PLANNING COMMISSION STAFF REPORT

Chick-fil-A Restaurant Planned Development Amendment PLNSUB2010-00112 1206 E 2100 South Public Hearing: July 14, 2010

SHEET TITLE
PRELIMINARY
SITE PLAN FOR
PLANNED DEV.
USE PERMIT

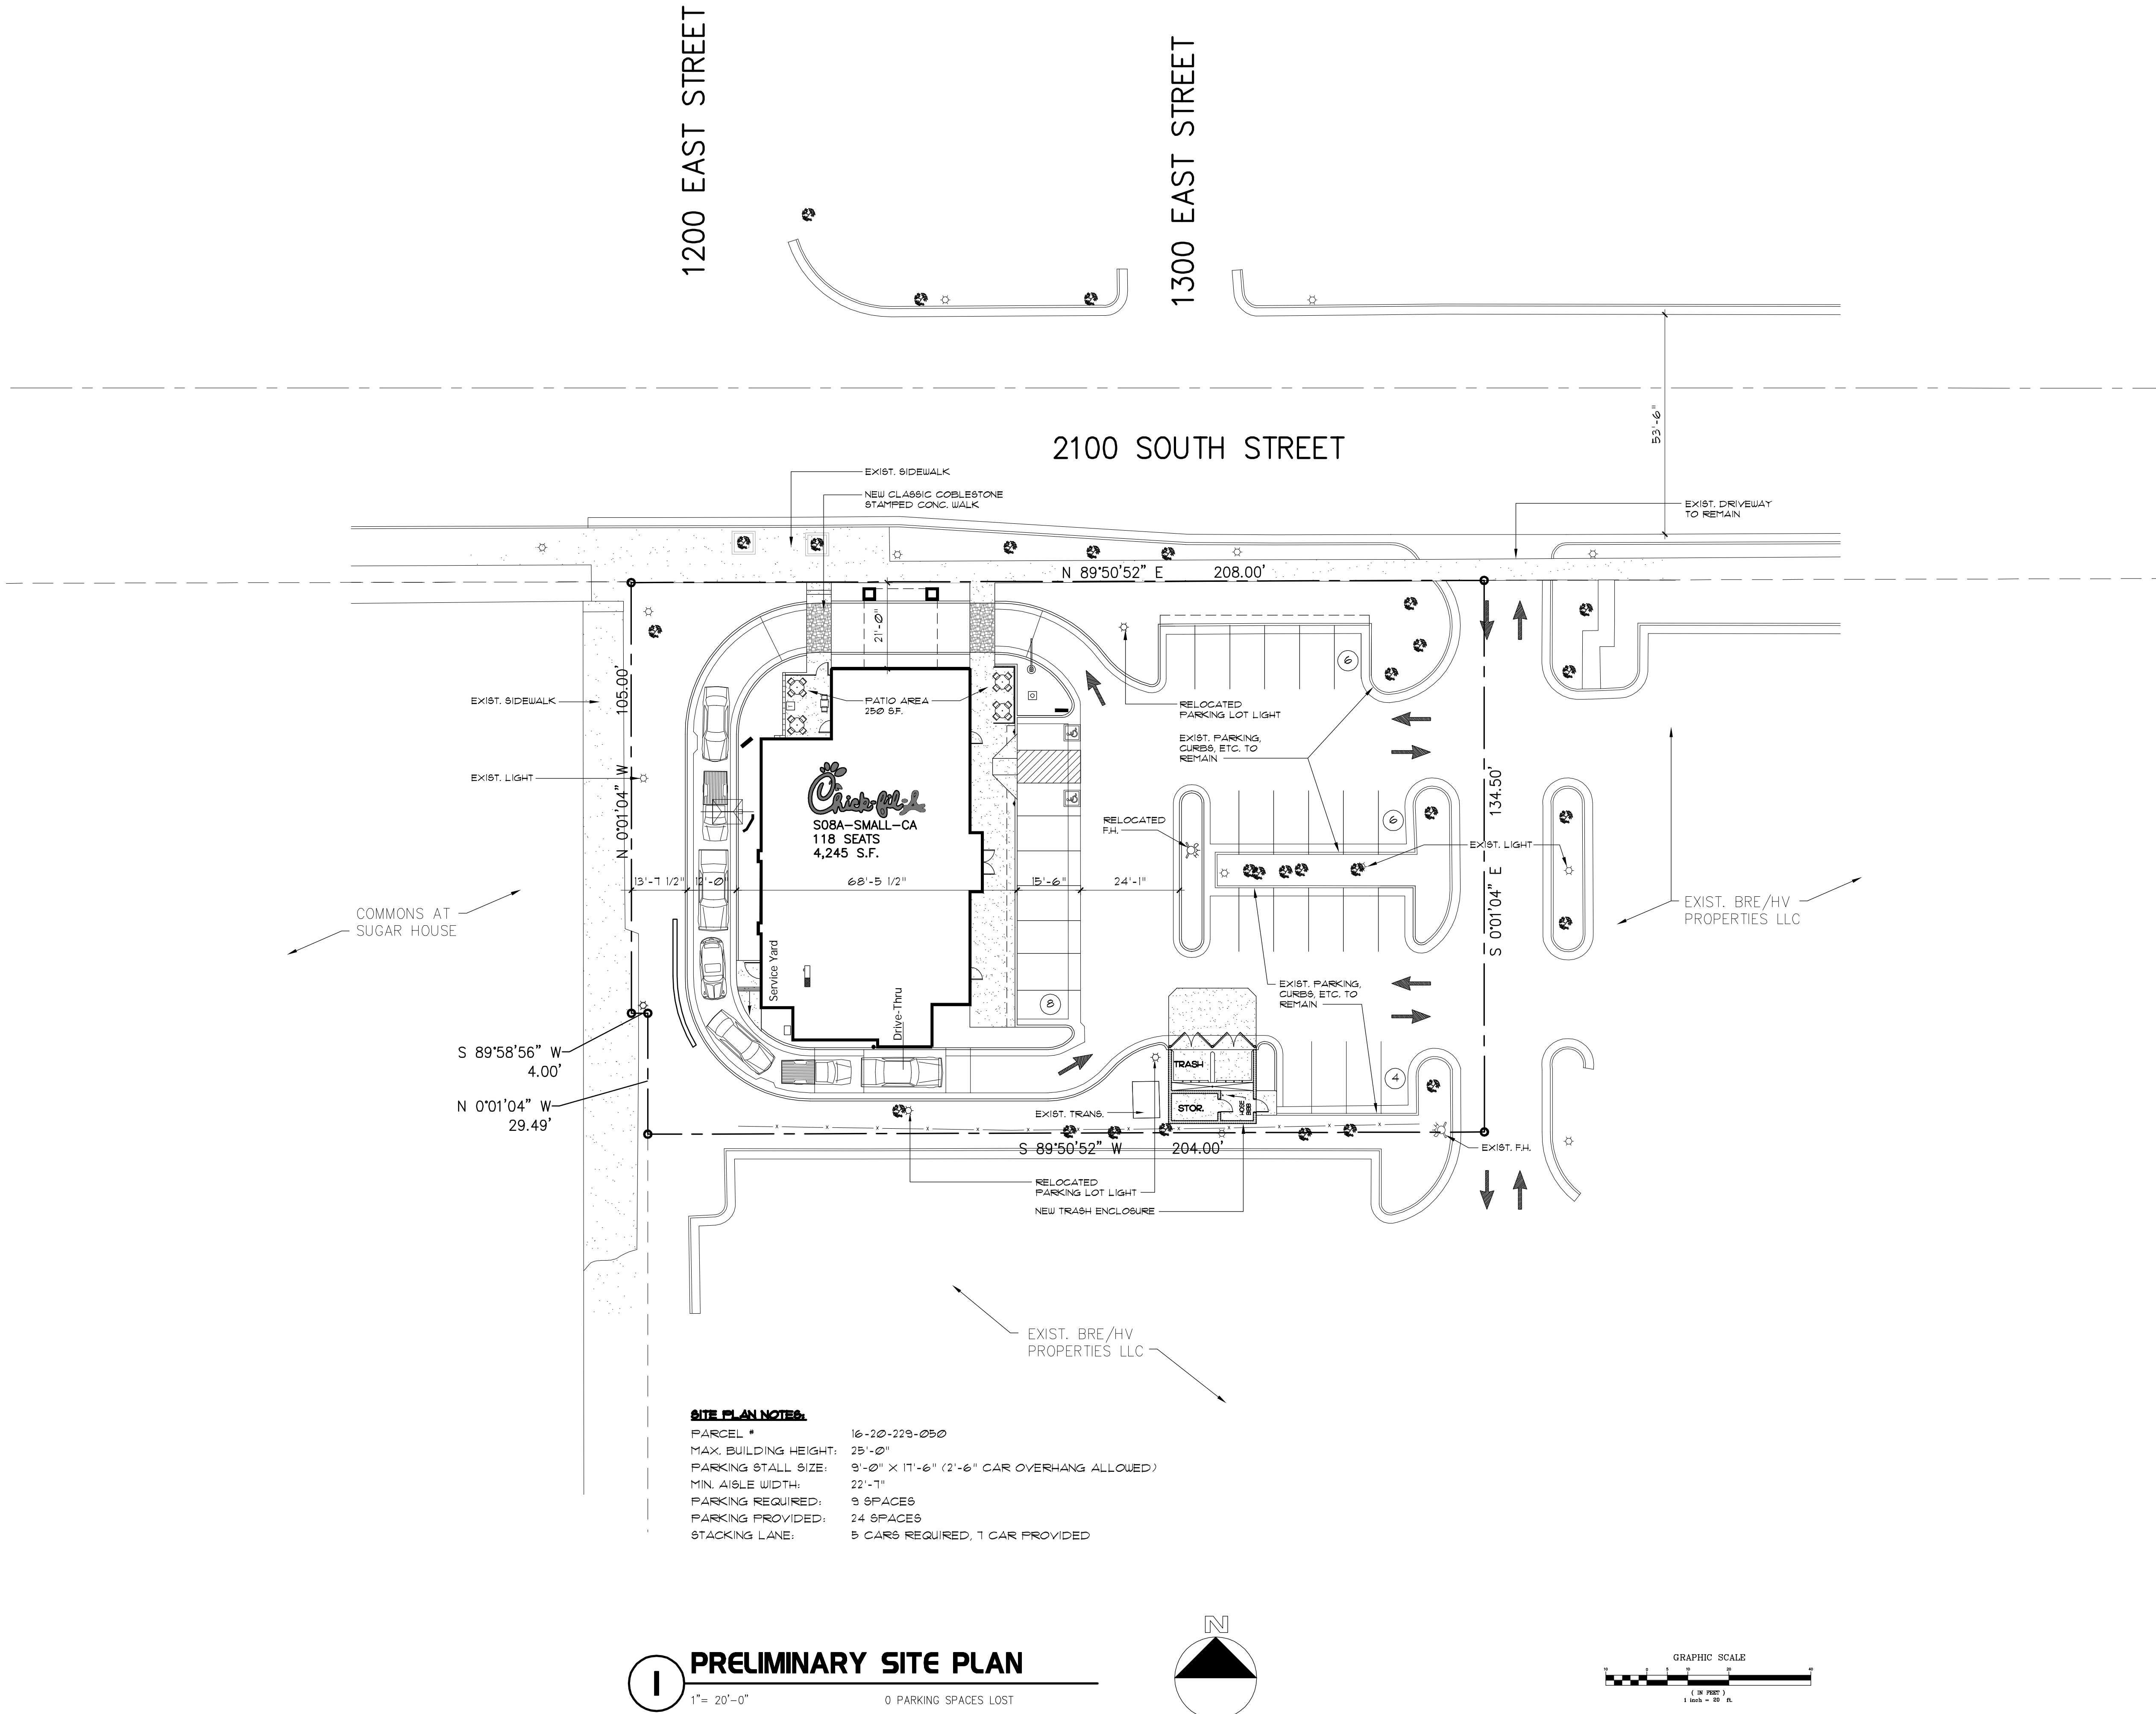
For transportation's final review, we need a fully dimensioned civil site plan showing parking stall width, depth, isle width, etc. we also need the dimensions of the drive-up isle width, radii, etc. include overhead awning height dimensions of 8'-2" minimum.

Please correct the parking calculations and include the ADA provision and the 5% bike parking with bike rack detail and location.

Demo existing building & re-certify address. Need verification access easements, P.U.D. Need parking calculation to include ADA & 5% bike. Drive up window requires 5 car stacking. (Show min. 18' inside radii & 28' outside radii-12' land). Outdoor dining over 500 s/f to be included in parking calculations.

SHEET TITLE
LANDSCAPE
PLAN

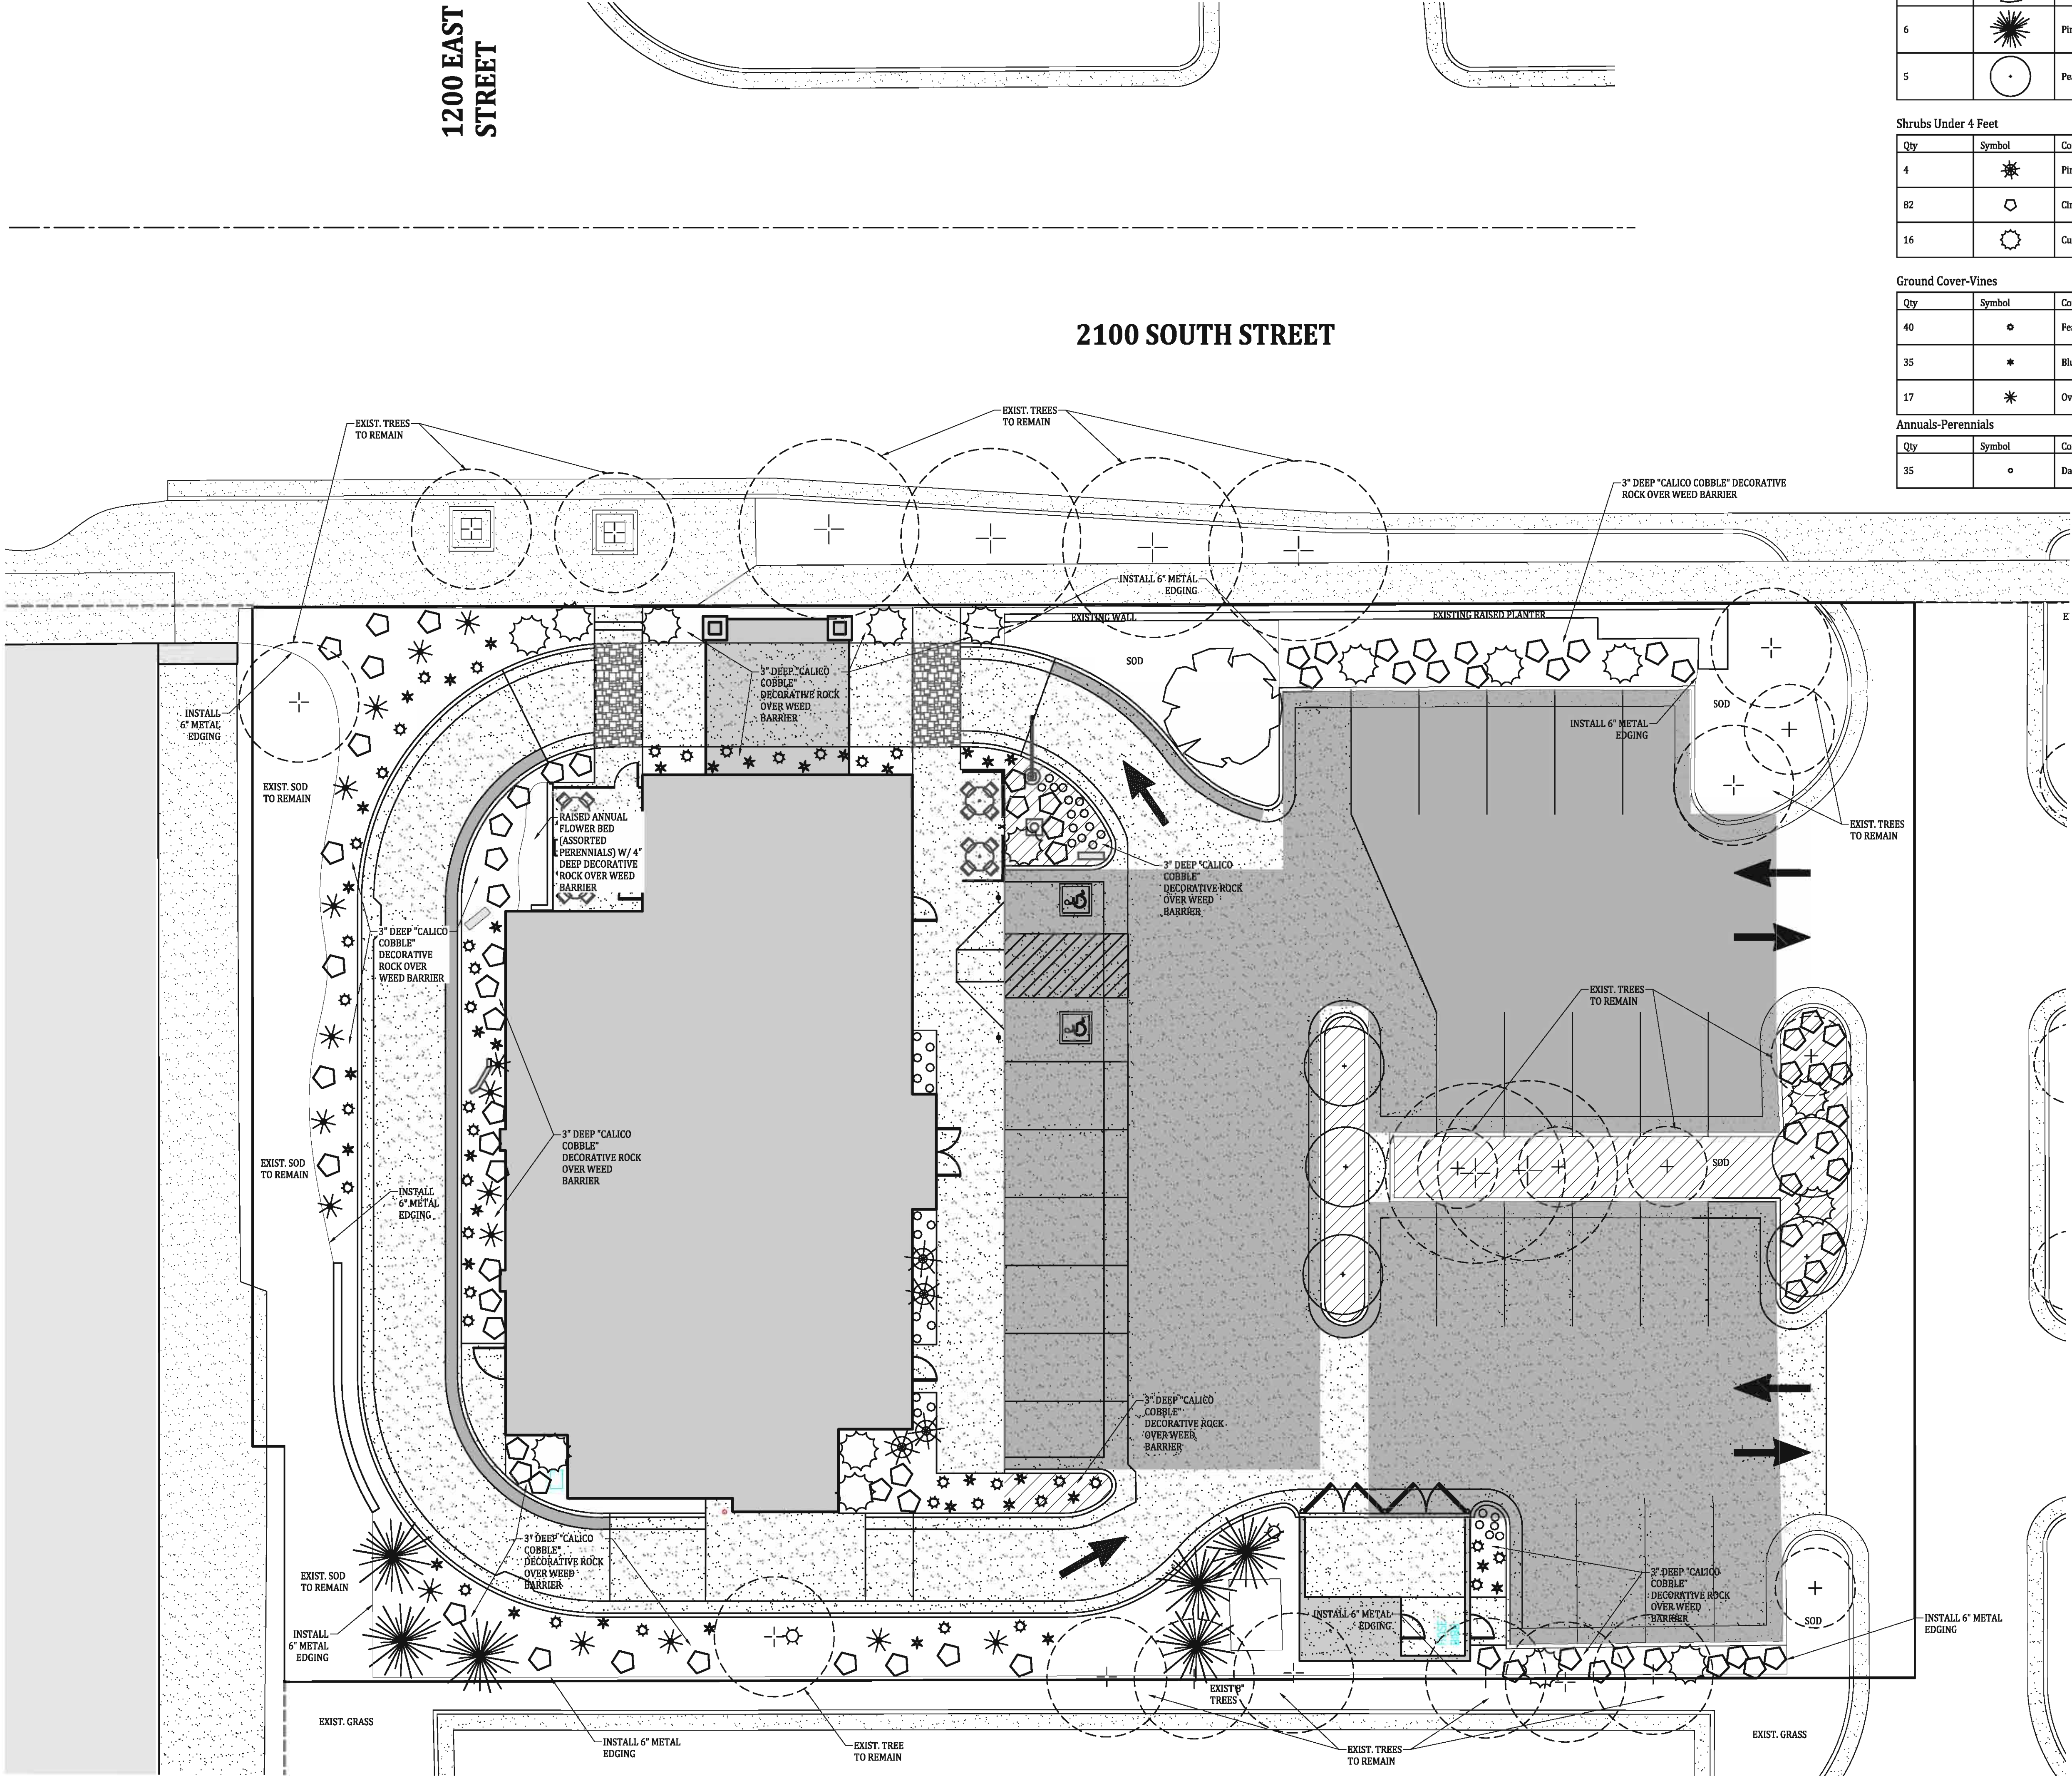
Analysis: The applicant intends to maintain the existing landscape islands and streetscape where most of the mature vegetation is located. Landscaping located adjacent to the existing restaurant will be removed and replaced with primarily drought tolerant species. However, staff recommends installation of organic mulch rather than the proposed gravel mulch to reduce heat and improve plant nutrition.

5. Applicant shall install and maintain a sufficient layer of organic mulch within all plant beds to reduce heat and improve plant nutrition.
 6. Where possible, additional accent lighting of architectural and landscape features is encouraged.
